SERVICE BULLETIN

N° 189-241

DATE: February 2, 2023

ATA 00 – INSTALLATION OF KIT 15000 FEET SERVICE CEILING

Figure 1

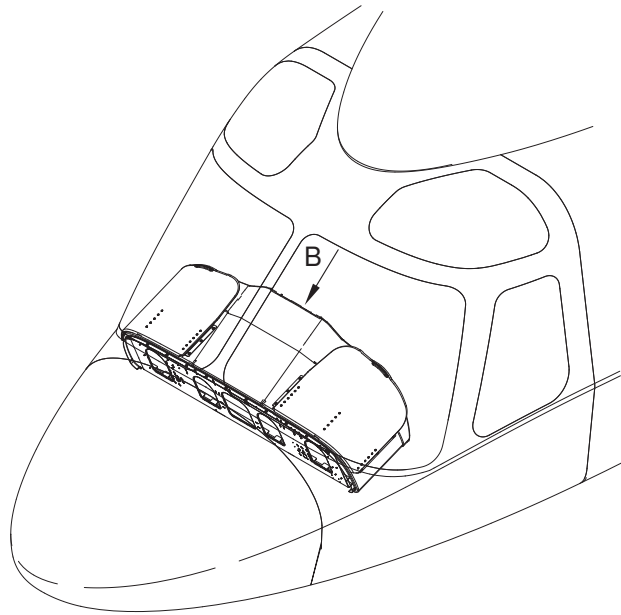
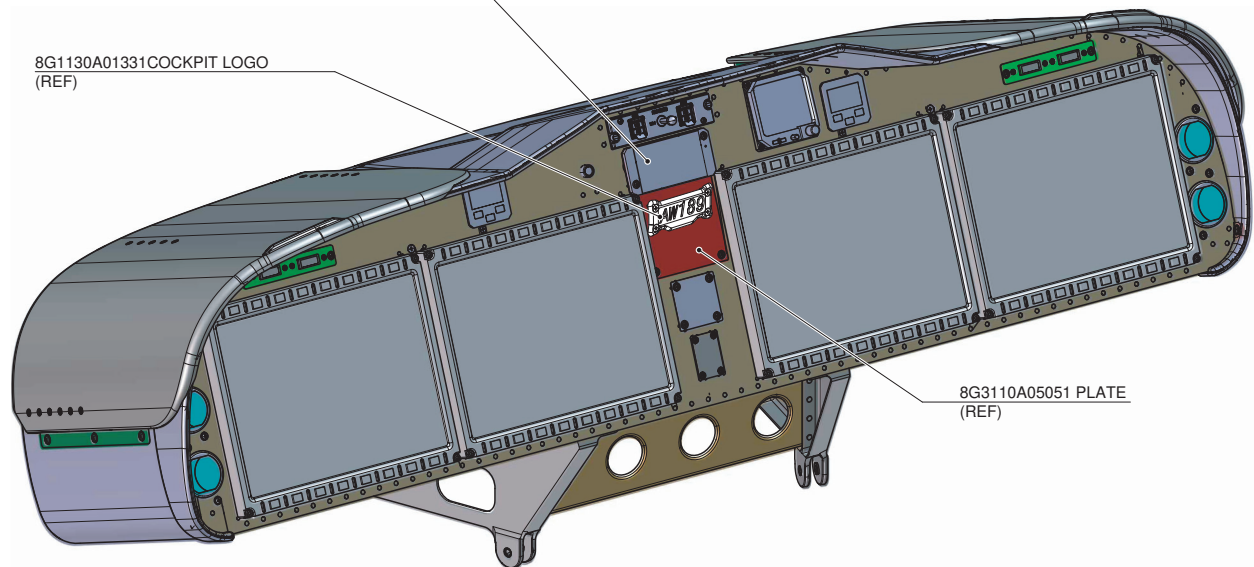
2. In accordance with AMP DM 89-A-06-41-00-00A-010A-A open access panel 481A, 461A, 463A and with reference to Figure 1, gain access to the engines area.

3. With reference to Figure 1, verify on the PT module nameplates that both engines are equipped with PT module P/N 5130T70G03 or later. The presence of the adequate P/N of the PT Module and S3N can be verified also in the engine log book.

Figure 3

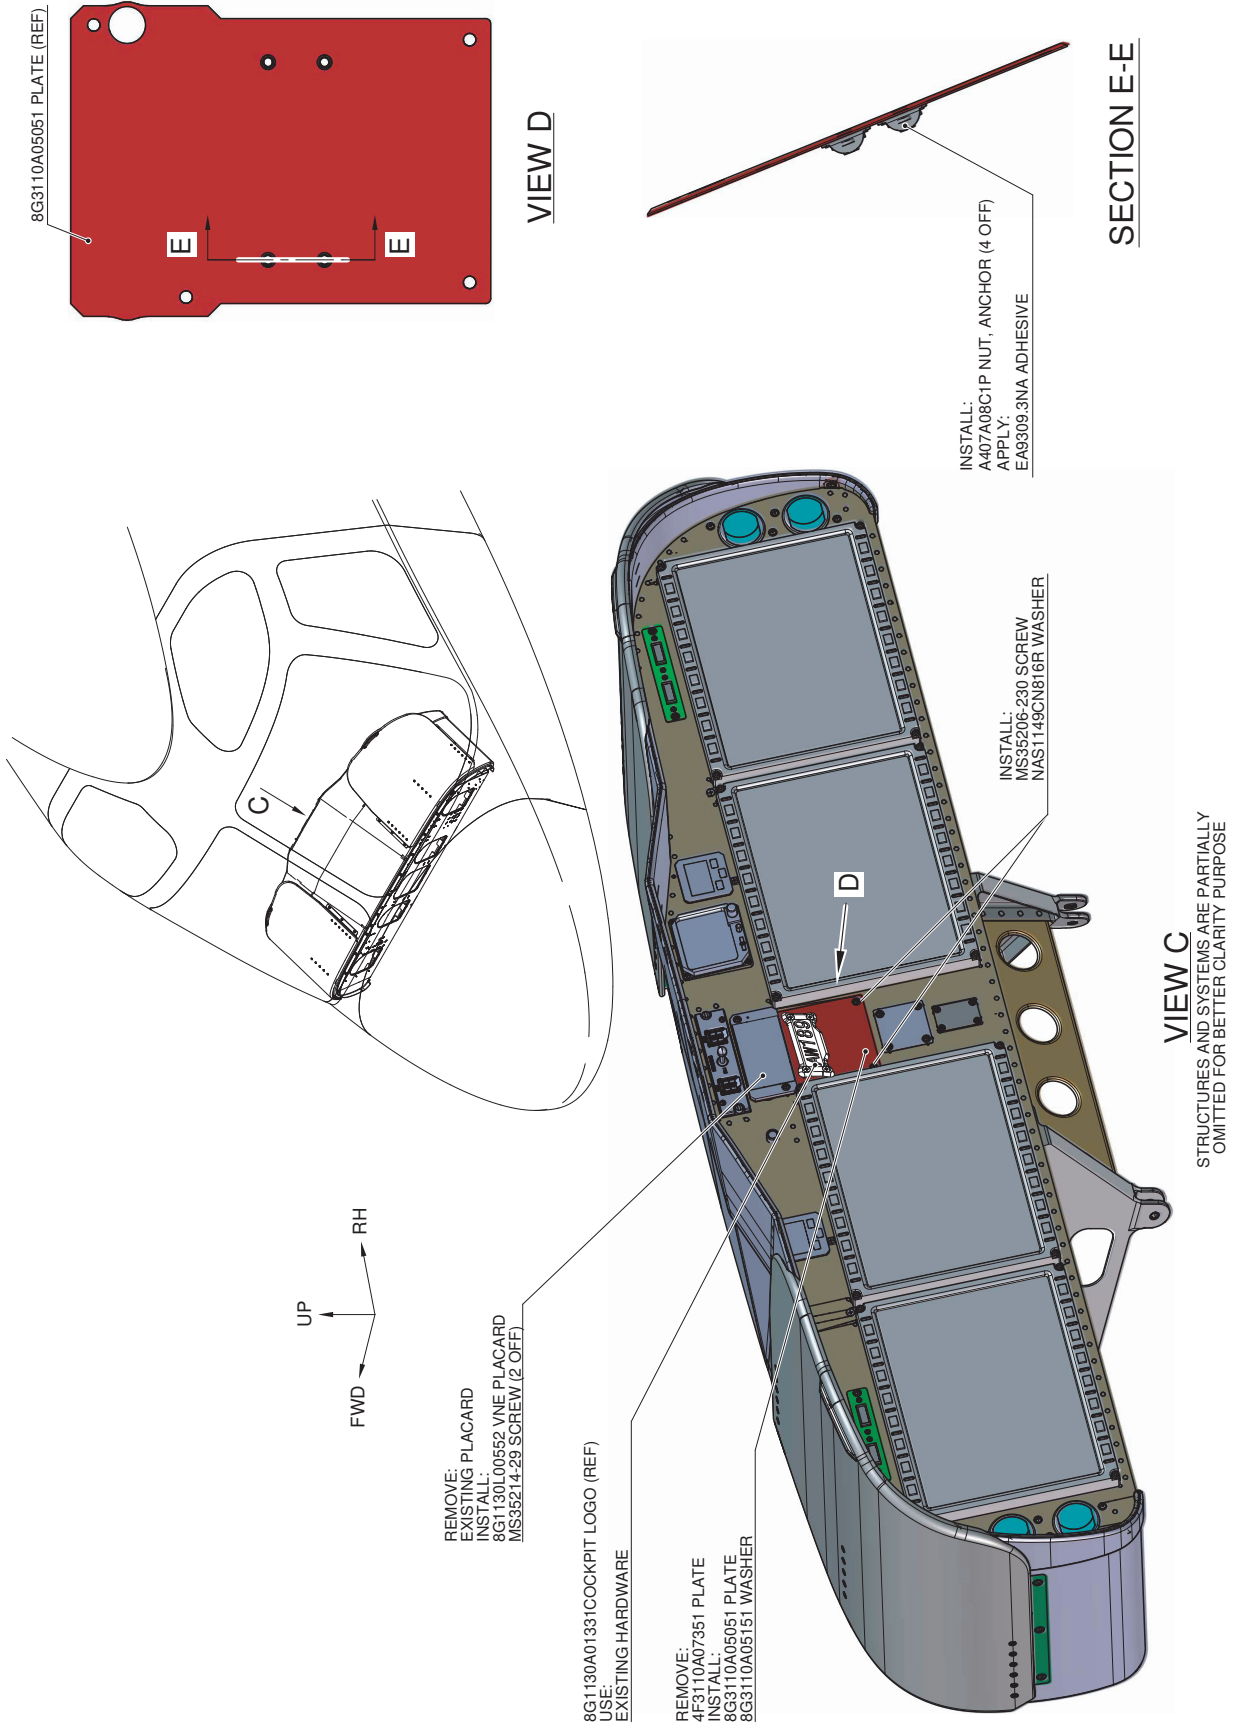
7. With reference to Figure 3, gain access to the cockpit area and perform the VNE placard retromod P/N 8G3110P00811 as described in the following procedure:

- 7.1 With reference to Figure 3 View C, remove the existing placard. Discard the existing hardware.
 - 7.2 With reference to Figure 3 View C, remove the cockpit logo P/N 8G1130A01331. Retain existing hardware for later reuse.

- 7.3 With reference to Figure 3 View C, remove plate P/N 4F3110A07351. Discard the existing hardware.
 - 7.4 With reference to Figure 3 View D and section E-E, install n°4 nut plates P/N A407A08C1P by means of EA9309.3NA adhesive on the plate P/N 8G3110A05051.

- 7.5 With reference to Figure 3 View C, install washer P/N 8G3110A05151 and plate P/N 8G3110A05051 by means of n°2 screws P/N MS35206-230 and n°2 washers P/N NAS1149CN816R.

- 7.6 With reference to Figure 3 View C, install VNE placard P/N 8G1130L00552 by means of n°2 screws P/N MS35214-29.
 - 7.7 With reference to Figure 3 View C, re-install the cockpit logo P/N 8G1130A01331. Use existing hardware.

Figure 4

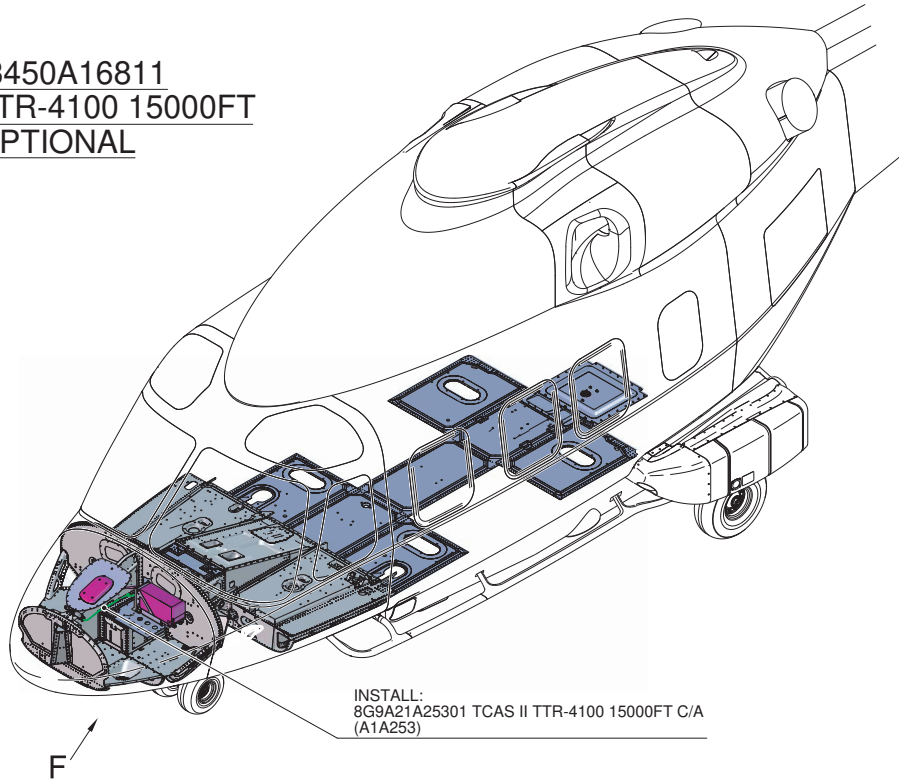
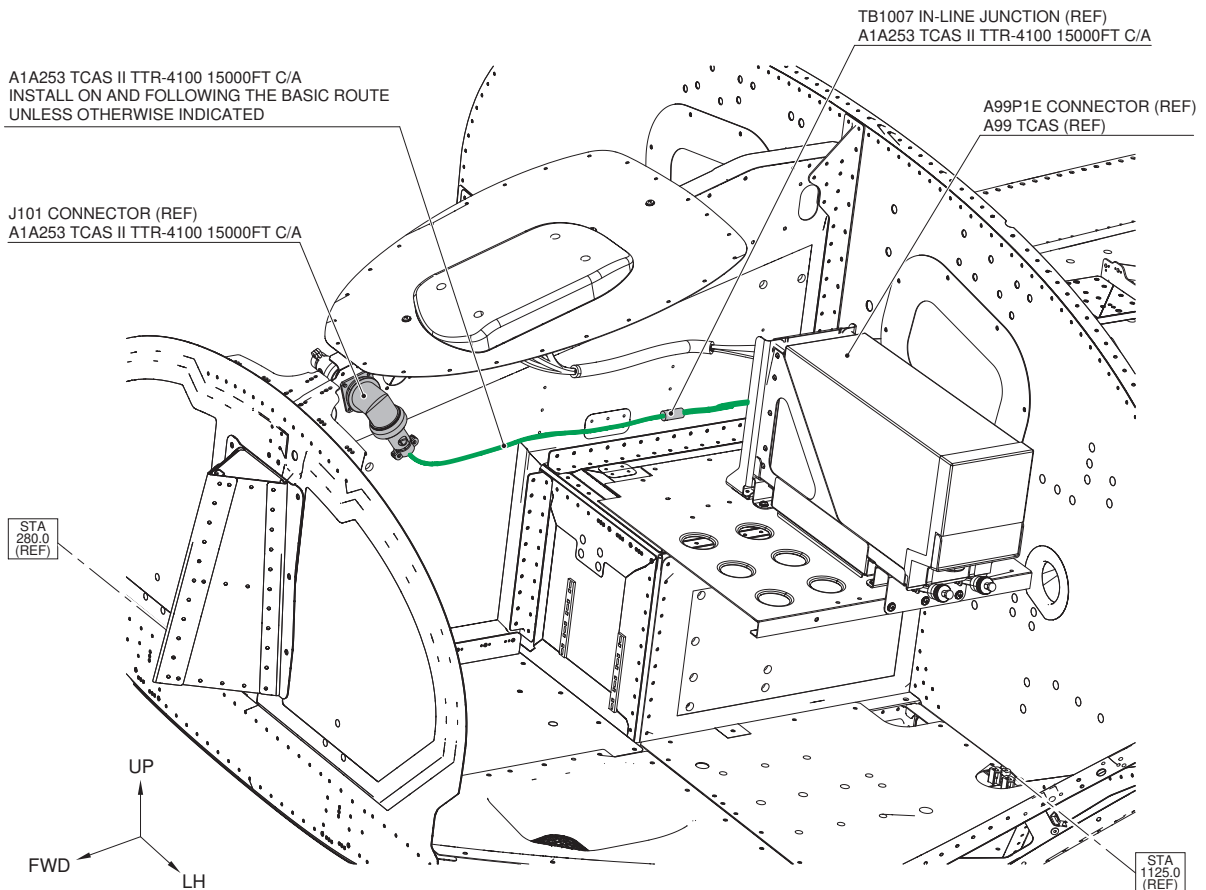
8. In accordance with AMP DM 89-A-06-41-00-00A-010A-A and with reference to Figure 4 and Figure 5 wiring diagram, gain access to the area affected by the installation and perform the “TCAS II TTR-4100 15000FT optional” P/N 8G3450A16811 as described in the following procedure:

- 8.2 With reference to Figure 4 and Figure 5 wiring diagram, cut n°1 wire P/N A556A-T22 of adequate length and lay down between in-line junction TB1007 and connector A99P1E following the existing route as shown.

INSTALL:
8G9A21A25301 TCAS II TTR-4100 15000FT C/A
(A1A253)

Figure 5

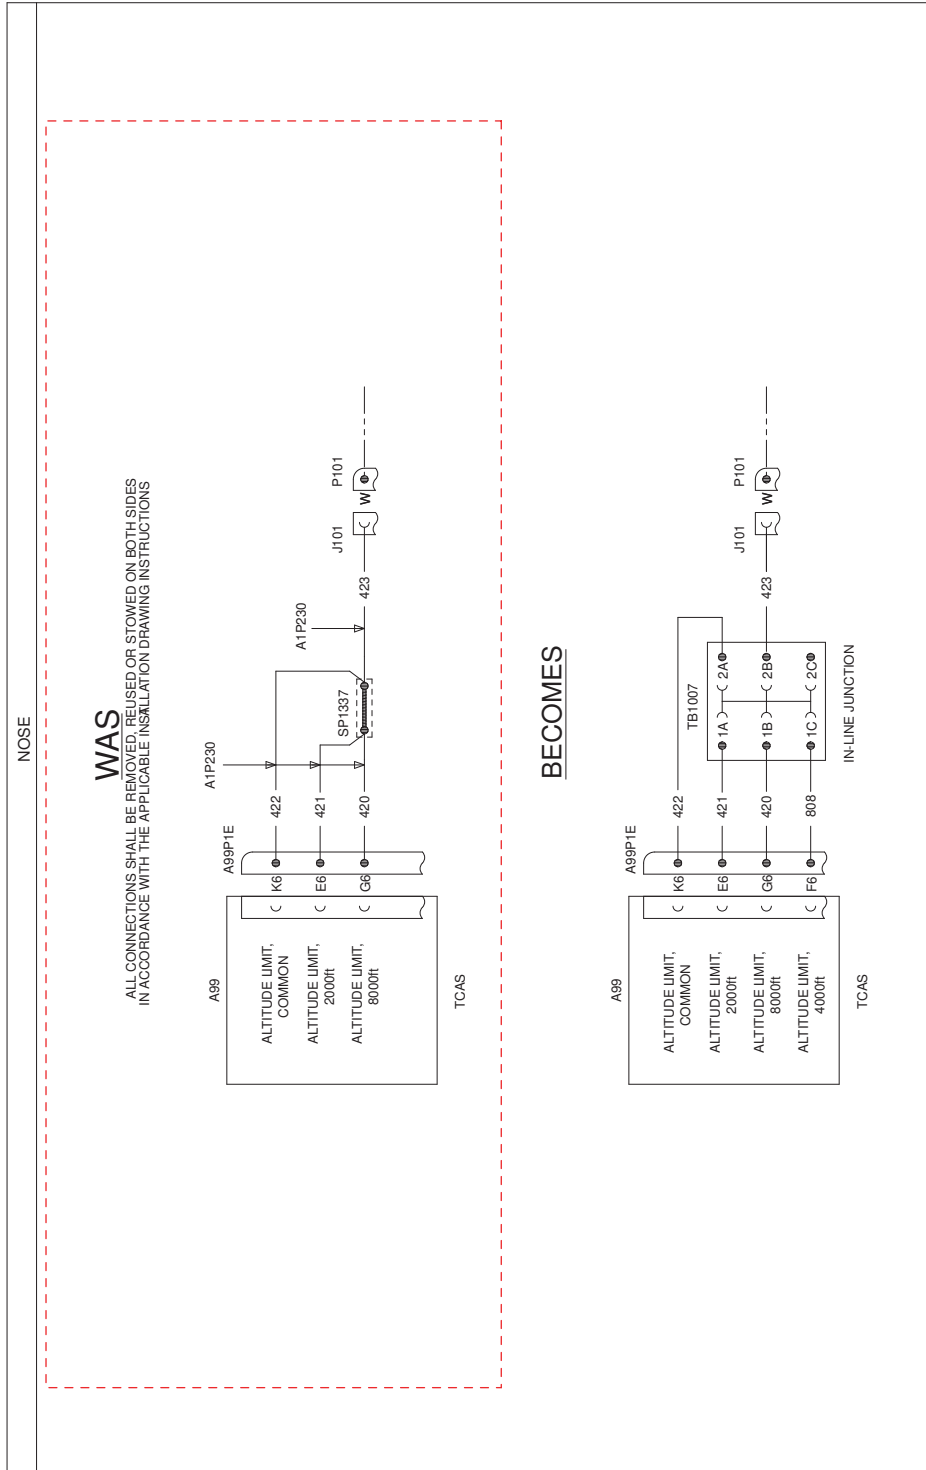
- 8.1 With reference to Figure 5 wiring diagram, remove the electrical connection between wires ID 422, 421, 420, 423 and splice SP1337. Remove and discard the splice SP1337.

- 8.3 In accordance with AMP DM 89-A-20-10-06-04A-720A-A and with reference to Figure 5 wiring diagram, mark wire as ID 808 by means of marker sleeve P/N A578A02-9.

- 8.4 In accordance with AMP DM 89-A-20-10-03-00A-010A-A and with reference to Figure 5 wiring diagram, crimp on wires n°5 electrical contact P/N A523A-A02 (TB1007 side) and n°1 electrical contact P/N 030-2259-000 (A99P1E side) by means of proper crimping tool.

- 8.5 With reference to Figure 5 wiring diagram, perform the electrical connection between in-line junction TB1007, connector J101 and connector A99P1E.
